Memo

To: John Holt, Lamoine Planning Board Chair

From: Robert Gerber, C.G.

Subject: Review of Summit Report on additional exploration at MacQuinn Pit and additional follow-up materials

Figure 4--Libby Brook Provisional Flows for 2013

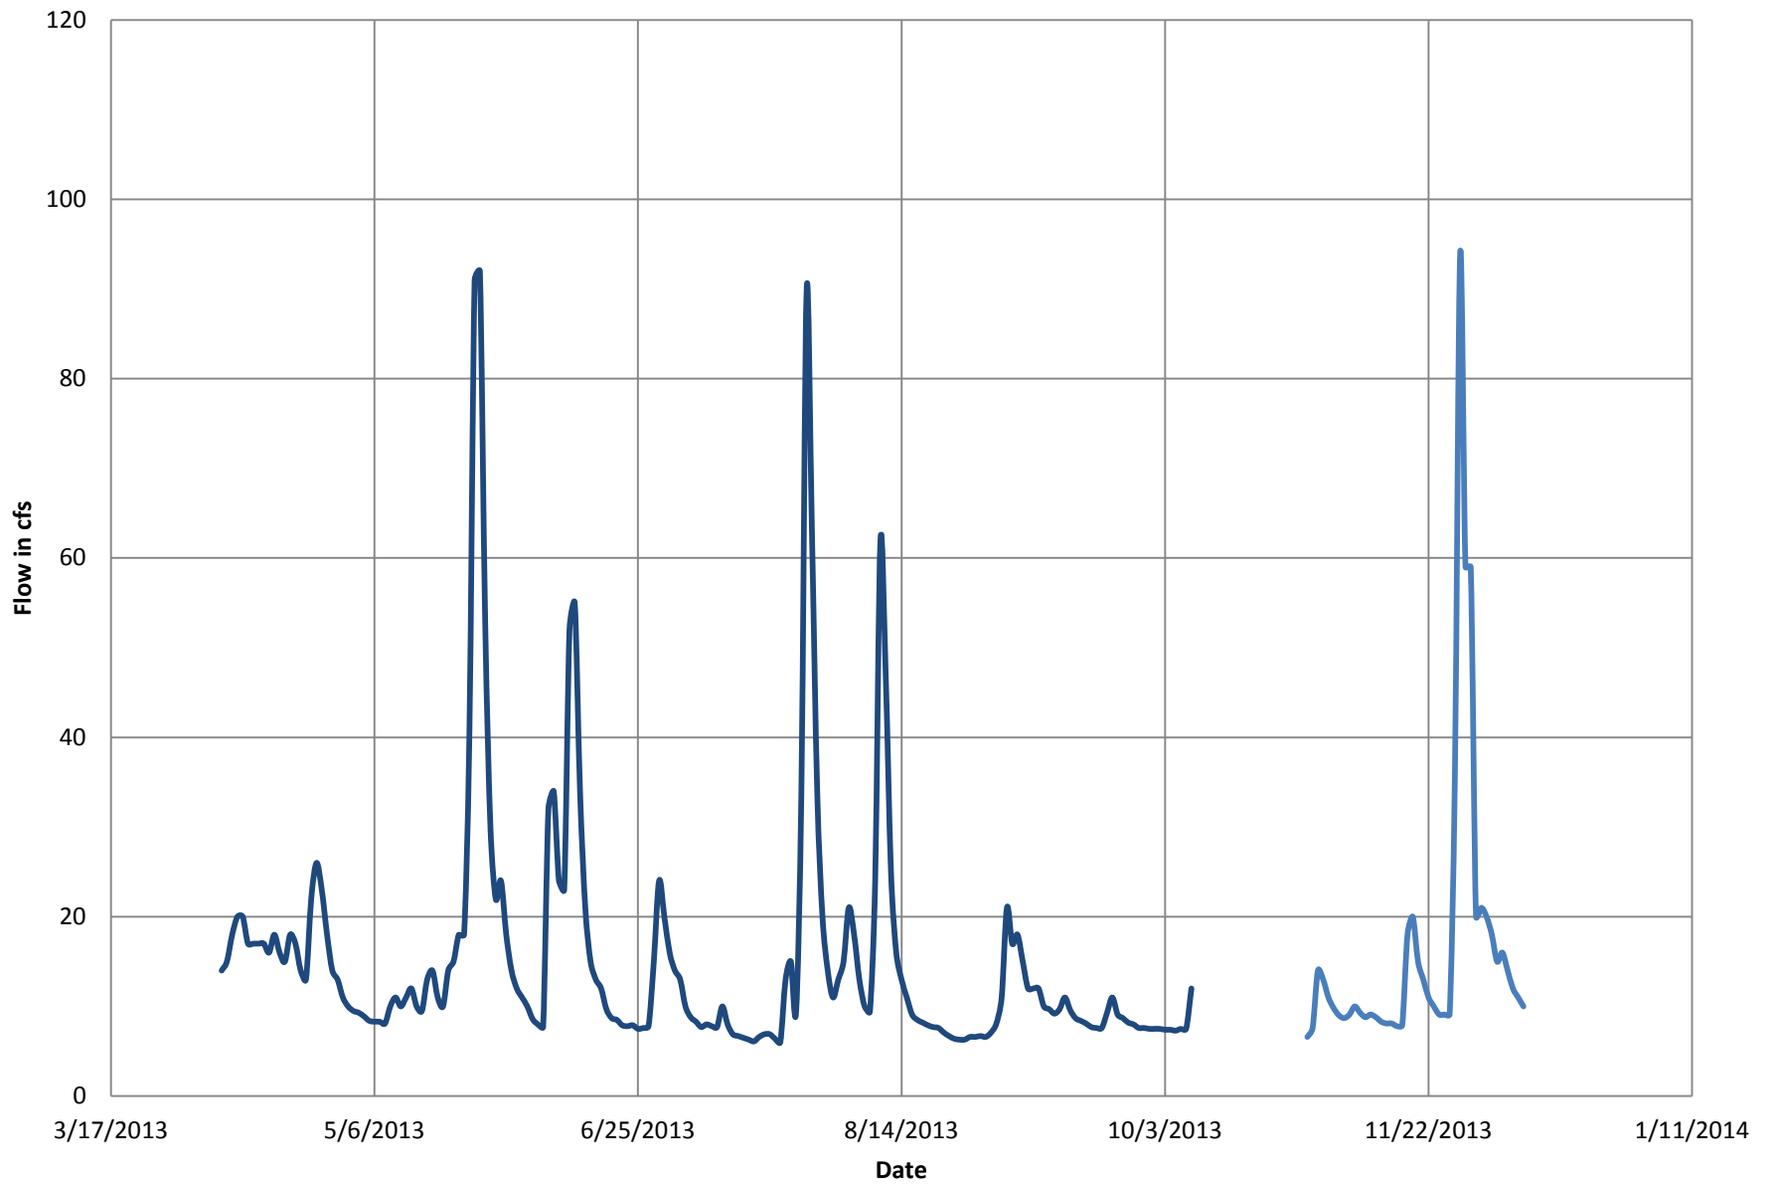
- 1) *Another complete synoptic (acquired at the same time) round of water level readings in the new monitoring wells and four older monitoring wells. All water levels were lower than the November 2013 readings.*
- 2) *A discussion of how the timing of the stream flow measurements used in the water balance computations related to whether they are baseflows only and whether these flows represent “average annual” base flows, fall high baseflows, etc. A discussion was provided comparing antecedent precipitation readings to the time of the stream flow measurements. The measurements were taken August 26, 2013, when flow in a small watershed in sand and gravel in Washington County was 6.3 cfs (see **Attachment 1**), which was about the lowest flow of the summer*

- in that watershed. Over the 13 years of stream gaging in Libby Brook, the lowest flows have typically been in August and September. So I think we can conclude that the measurements at the time of flow were less than the average baseflow for the year.

**SUPPLEMENTAL
WATER BALANCE
CONTRIBUTION AREAS**

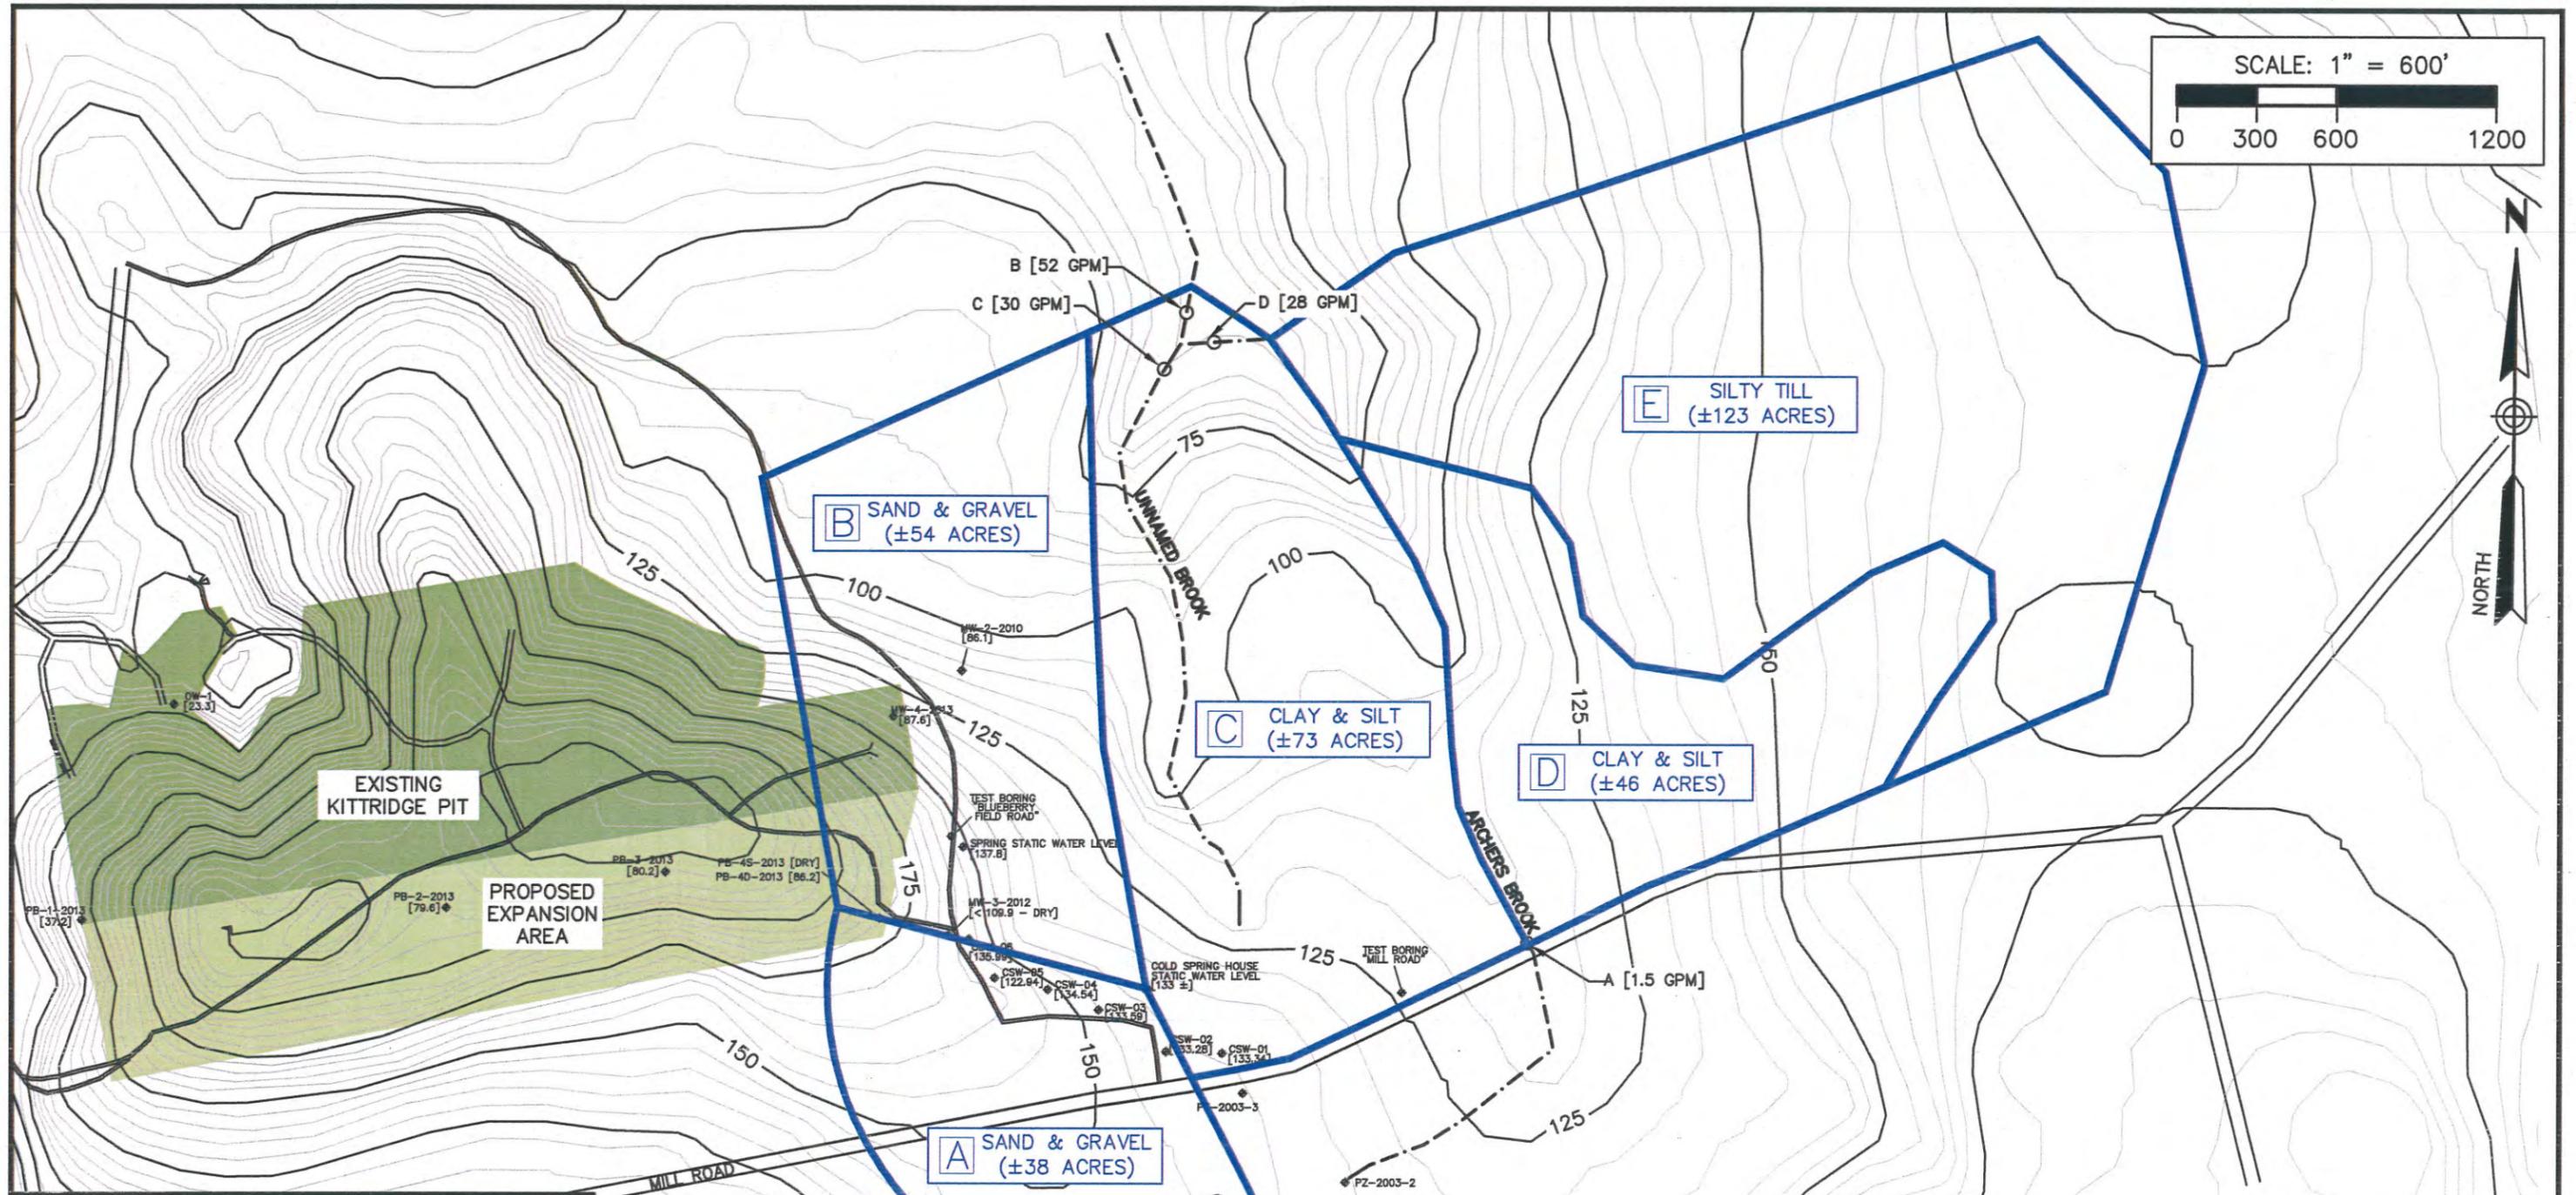
As to the contributing recharge area to Cold Spring, we have the revised Summit recharge area delineation from Summit's revised water balance analysis of March 20, 2014 (**Attachment 2**) which gives us a general interpretation of the recharge area and surficial geology of different portions of the recharge area. In addition, I have prepared a contour map of the shallow water (perched) table that seems to be related to Cold Spring as **Attachment 3**. **Attachment 3** was prepared by entering the x and y coordinates of all of the points of known (measured) and inferred (streams with approximate LiDAR elevations) water table, converted elevations to NAVD88 datum and contoured the data using a simple linear interpolation procedure. There are two groundwater "highs" that

Bullet 6—*The recharge area of Cold Spring does not make sense based on Summit's December 2013 map.* This is a lengthy bullet that covers a lot of ground and offers opinion. Even the more recent March 2014 revised recharge area map that was submitted by Summit with their March 20, 2014, memo does look strange to the south of Cold Spring. But if you look at my **Attachment 3**, which is a contour map based on linear interpolation of the available shallow groundwater elevations, there does appear to be an avenue of groundwater flow from the south toward Cold Spring that makes sense hydraulically as I discuss on the bottom of page 3 and top of page 4 of this memo. Again, although it would nice to unravel all the secrets of Cold Spring, I do not think that the Applicant should be required to do that as we already know what we need to know to evaluate the proposed gravel pit expansion area.

Elevation Contours of Shallow Ground Water Table (NAVD88, ft.)
Town of Lamoine, MacQuinn Gravel Pit Expansion Review
Digital Elevation Model Developed from 2-m LiDAR
Grid is UTM, NAD83, 19N, meters
RGG 3-26-14 131.06066

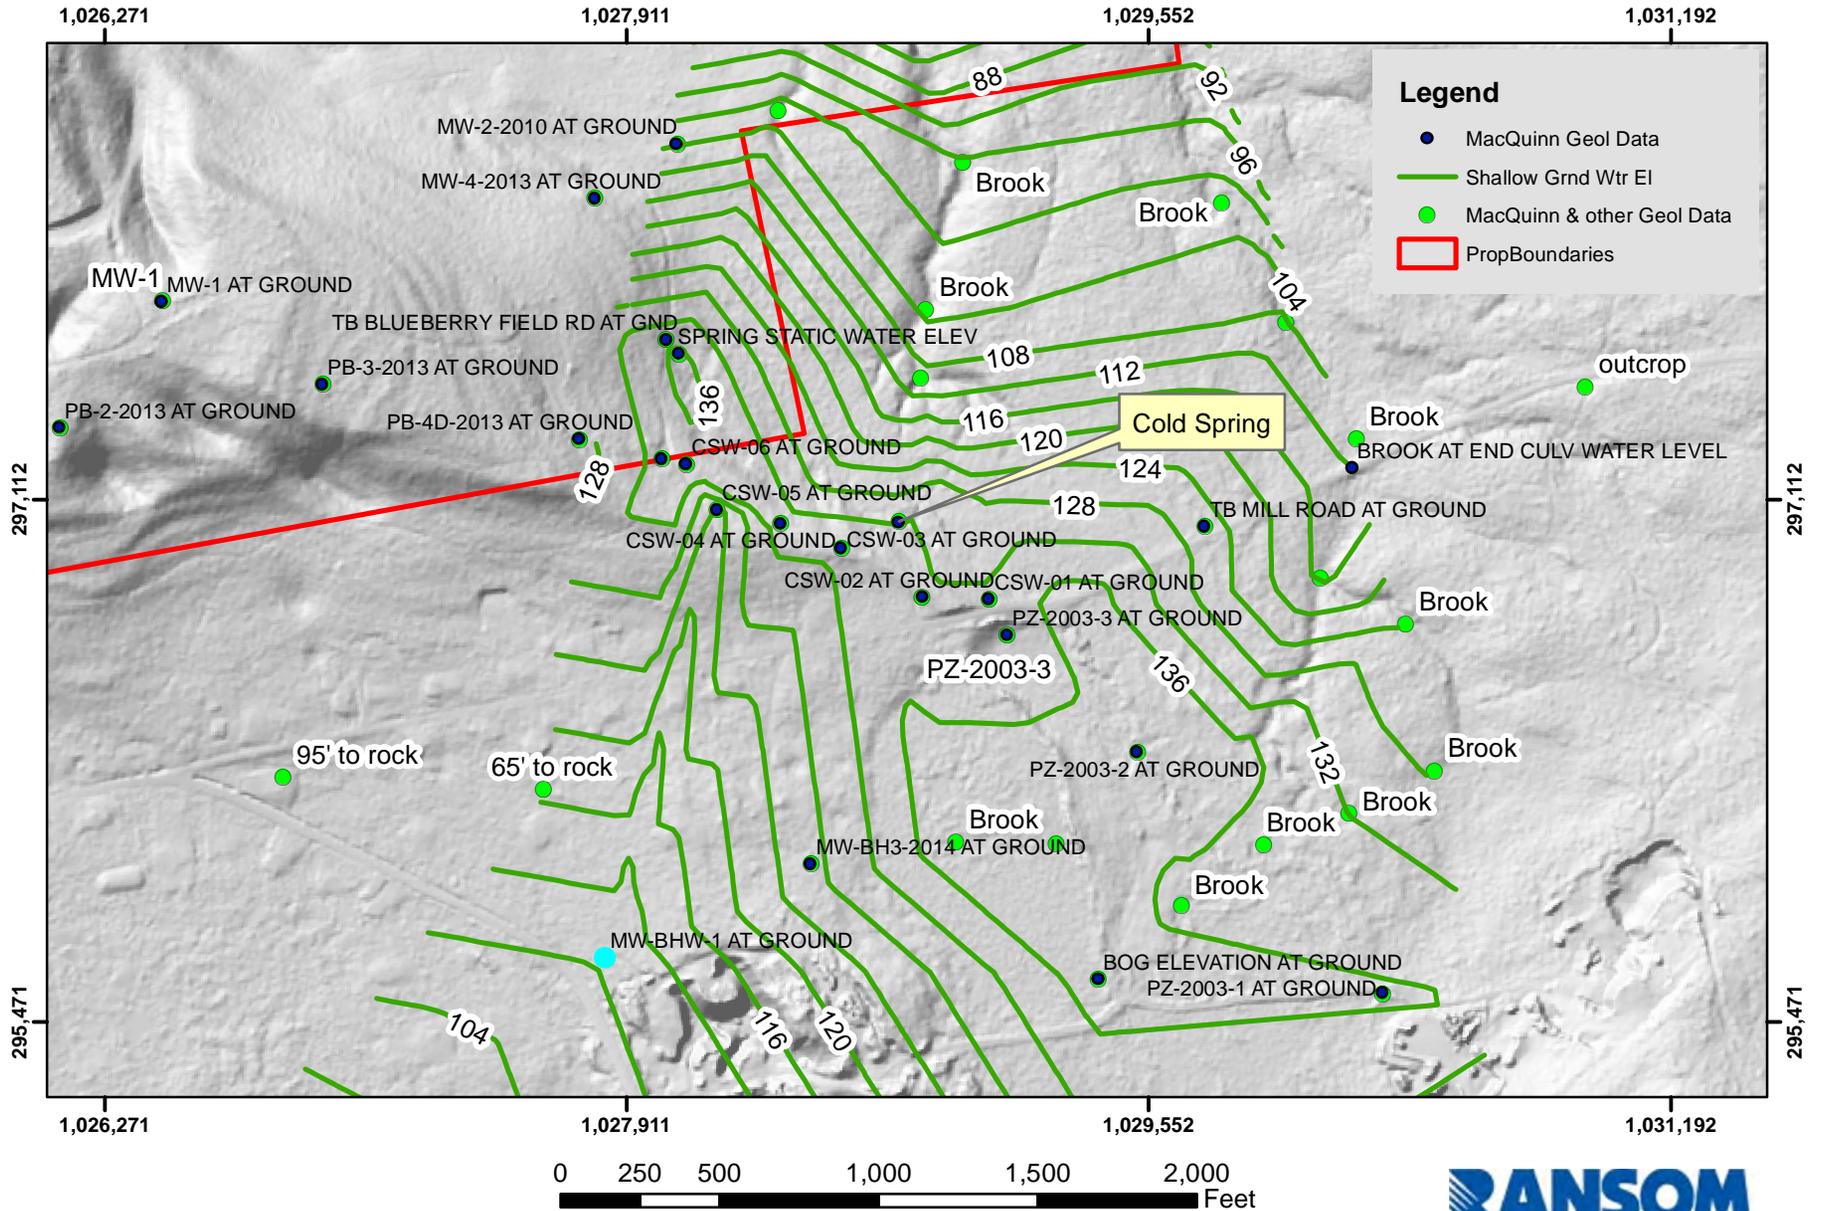
seem to feed the Cold Spring, assuming groundwater flowlines are more or less perpendicular to the groundwater contours on **Attachment 3**. The smaller of the two watersheds seems to extend northwest from Cold Spring and extend along the northern side of the string of CSW monitoring wells, terminating near a small high in the water table identified as elevation 136' on the figure. One anomaly along this area is the significantly lower groundwater elevation at CSW-05. The other portion of the recharge area and the portion that is probably more likely to keep the relatively constant level in the spring is the large recharge area suggested by the closed contour of elevation 136 to the south of Cold Spring, which includes a bog area. There is a suggestion that along the western edge of this closed contour there is a connection and shallow groundwater flow to the north that passes through the area of CSW-02 and CSW-03, entering gravel where the ground surface is almost 30 feet higher than the water table elevation, and passing through the Cold Spring area. There is sufficient watershed area to supply the 12 gpm withdrawal rate from Cold Spring.

Bullet 2—*The topography of the land near Cold Spring suggests that the surficial soil is fine-grained and not sand and gravel.* I disagree. The stream pattern development as displayed on **Attachment 3** is suggestive of groundwater sapping within a material like sand, possibly underlain by clay-silt. A similar pattern can be observed, for example, in the upper reaches of Branch Brook in Kennebunk (**Attachment 4**) where a thick sand overlies clay and groundwater seeps out of the sand over the top of the clay.
